SULLIVAN SUBDIVISION PLAN
TAX MAP 19 AND LOT 68
8 WHITTAKER DRIVE, STRATHAM, NH 03885

Plan Name:	COVER SHEET
Project:	SULLIVAN SUBDIVISION 8 WHITTAKER DRIVE, STRATHAM, NH 03885
Owner of Record:	ROBIN SULLIVAN 8 WHITTAKER DRIVE, STRATHAM, NH 03885

**Stratham Planning Department
Department Head/Commission Project Review Form**

Plan Name: **SUBDIVISION PLAN**
Project: **MAP 19, LOT 68**
Owner of Record: **SULLIVAN SUBDIVISION**
8 WHITTAKER DRIVE, STRATHAM, NH 03885
ROBIN SULLIVAN
8 WHITTAKER DRIVE, STRATHAM, NH 03885

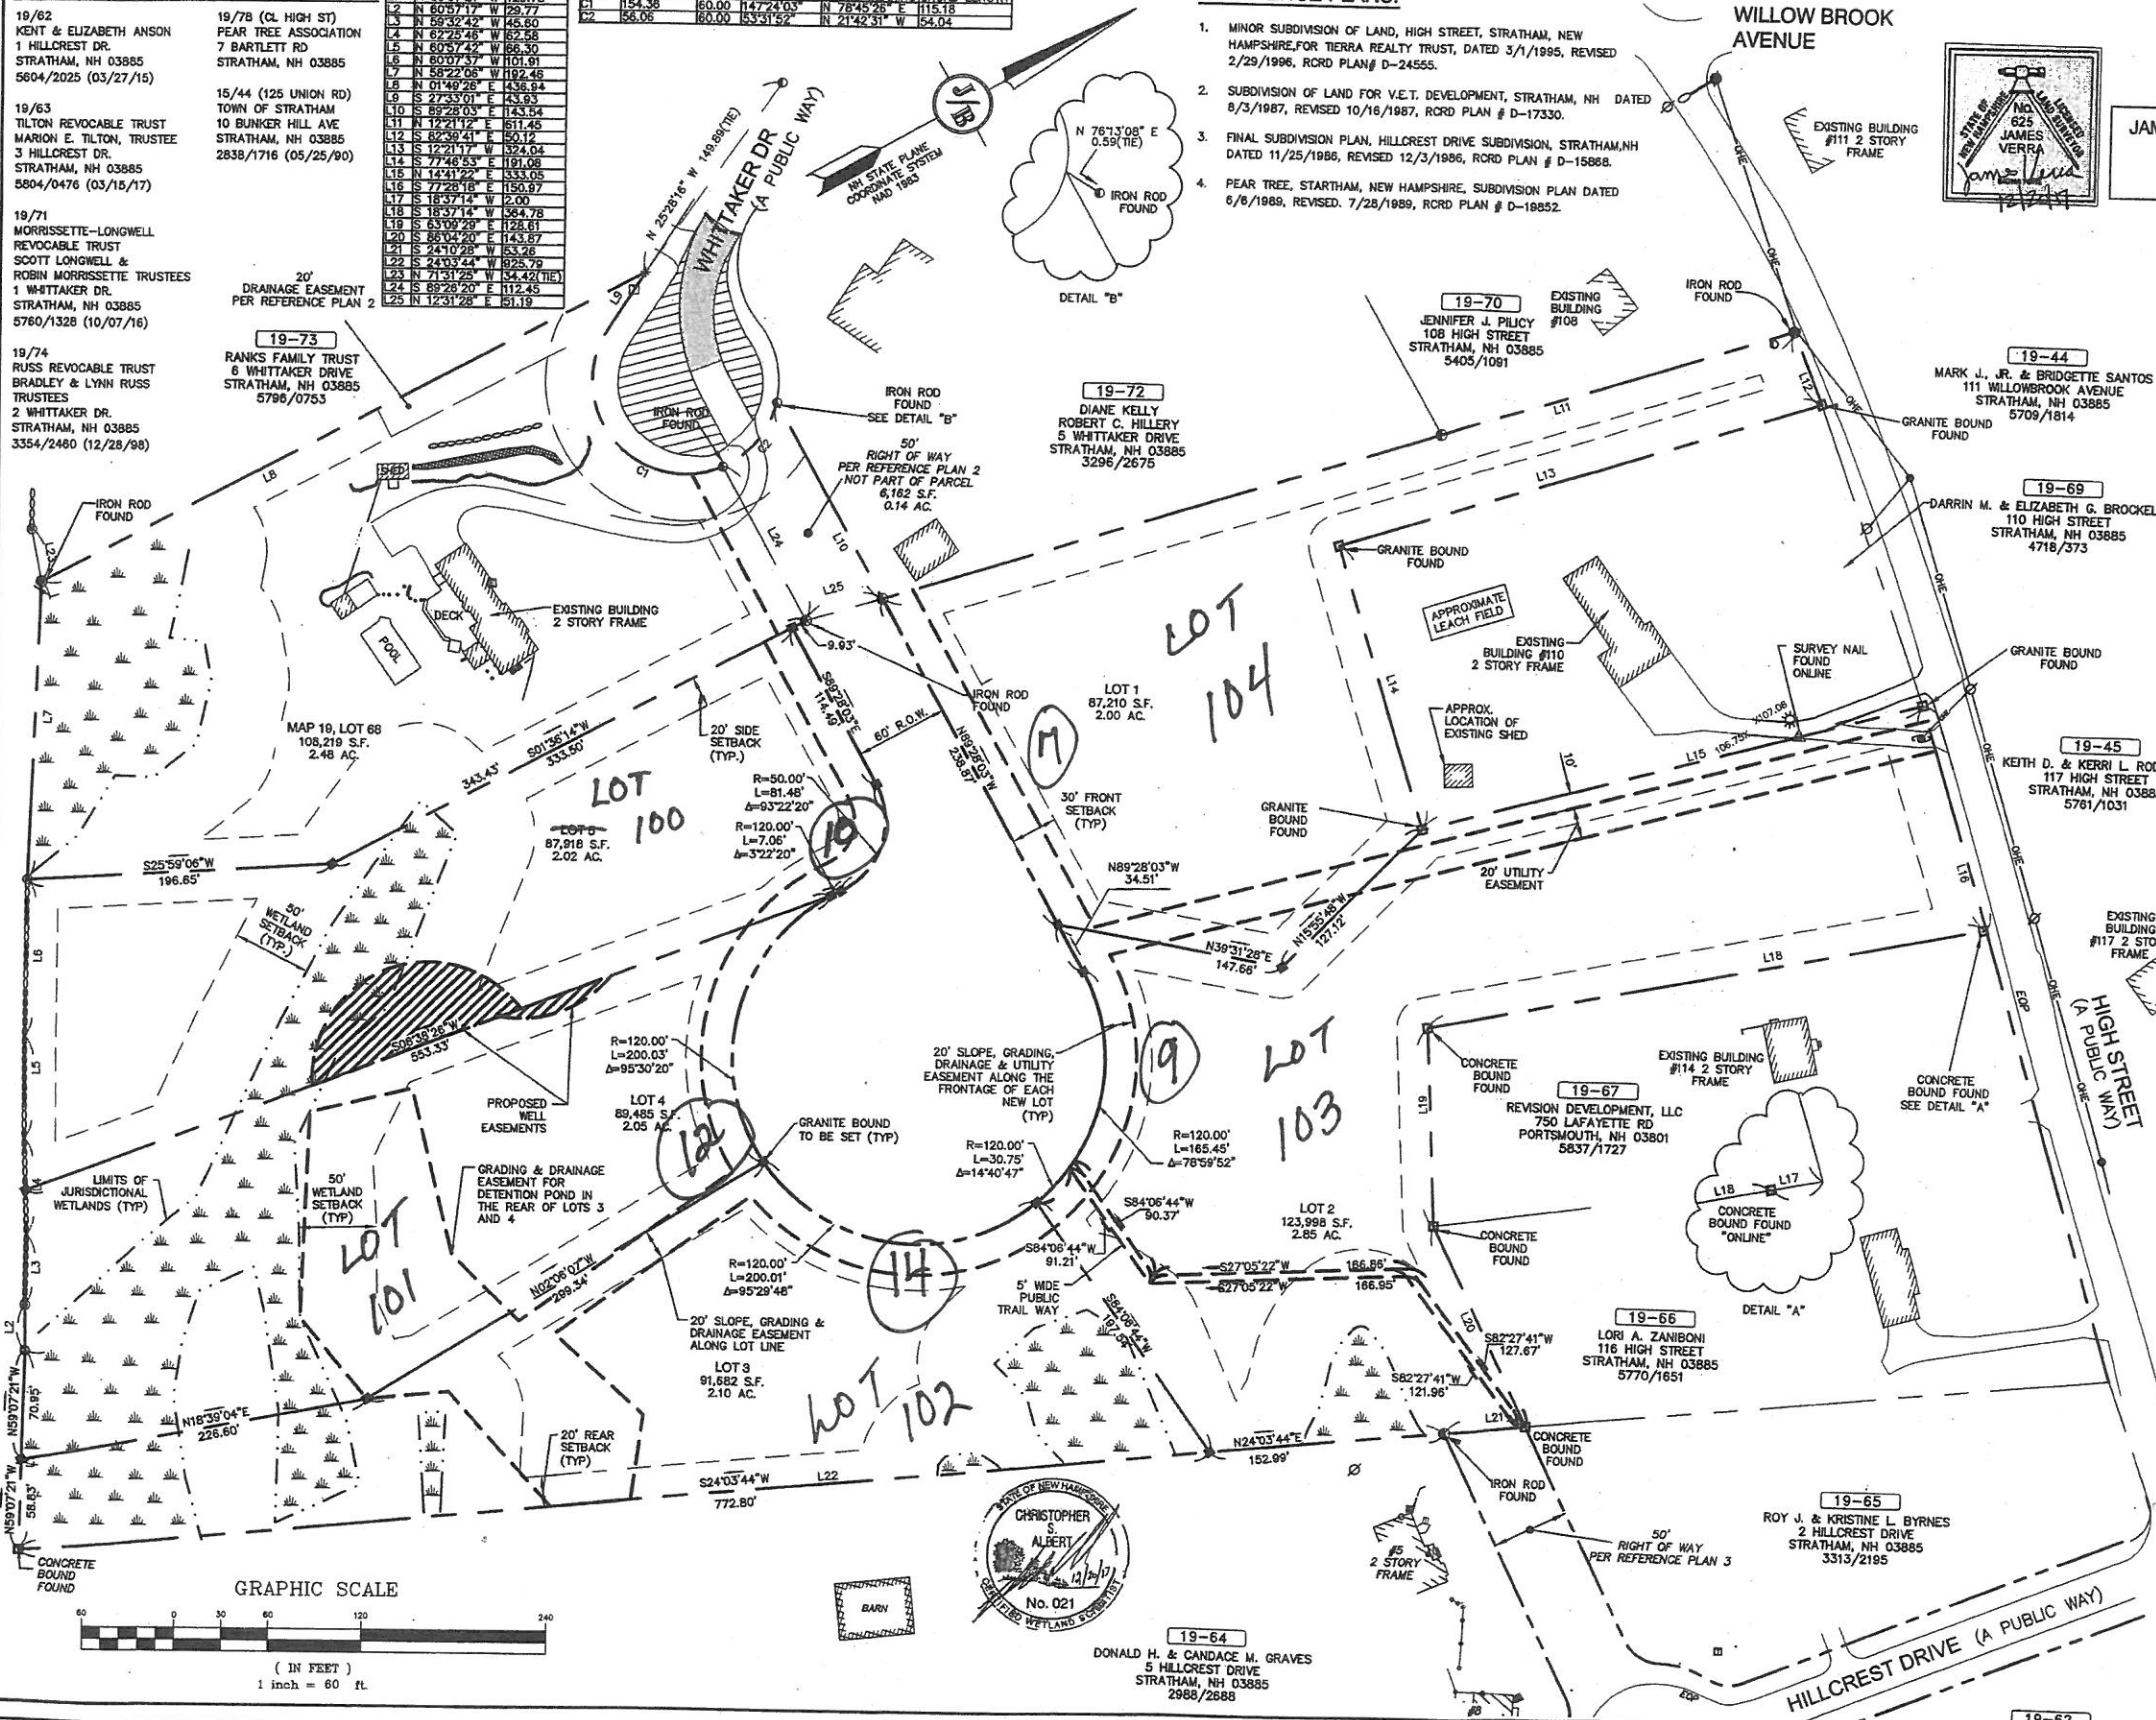
Plan received 12/20/2017 - appears to have the same acreage as the 10/18/2017 PB meeting. Lot numbering should be the same as April/May & October plans submitted. See attached:

Plan Name: **PROPOSED WATERSHED PLAN**
Project: **112 HIGH STREET
STRATHAM, NH 03885**
Owner of Record: **ROBIN SULLIVAN
8 WHITTAKER DRIVE, STRATHAM, NH 03885**

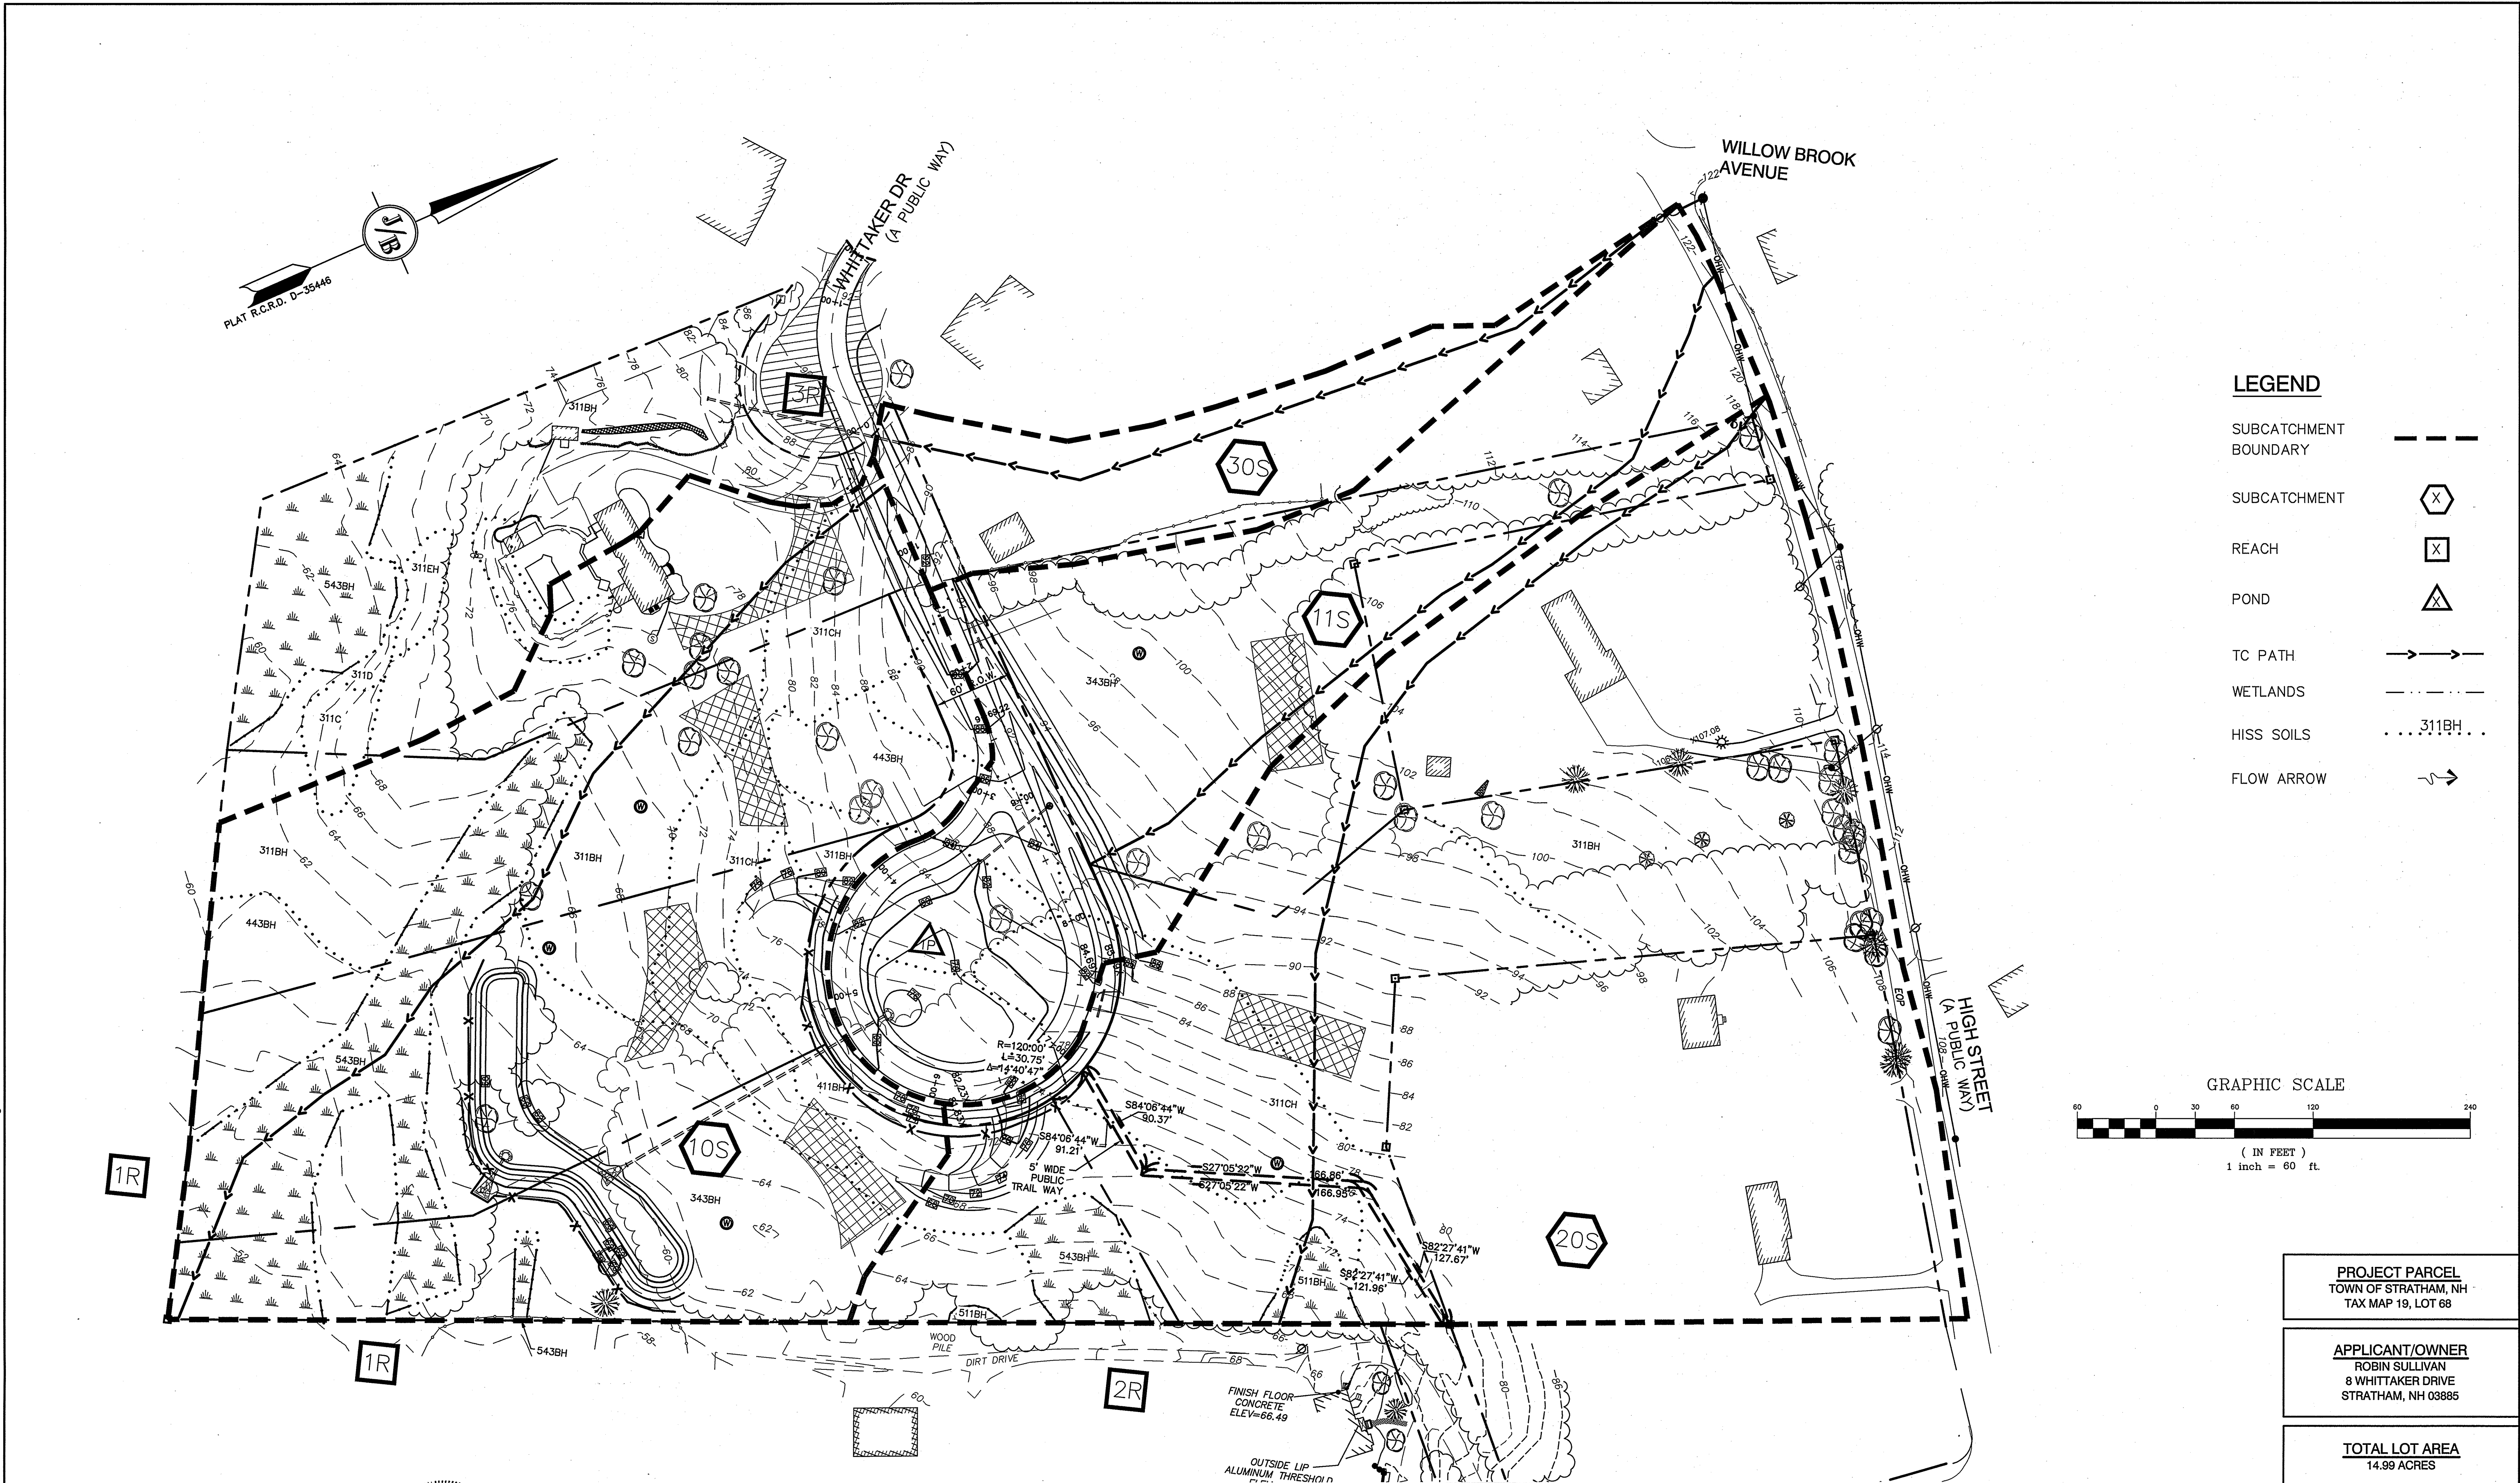
Here is the soil map. Please note when you mark it up to change the 323 to 343:
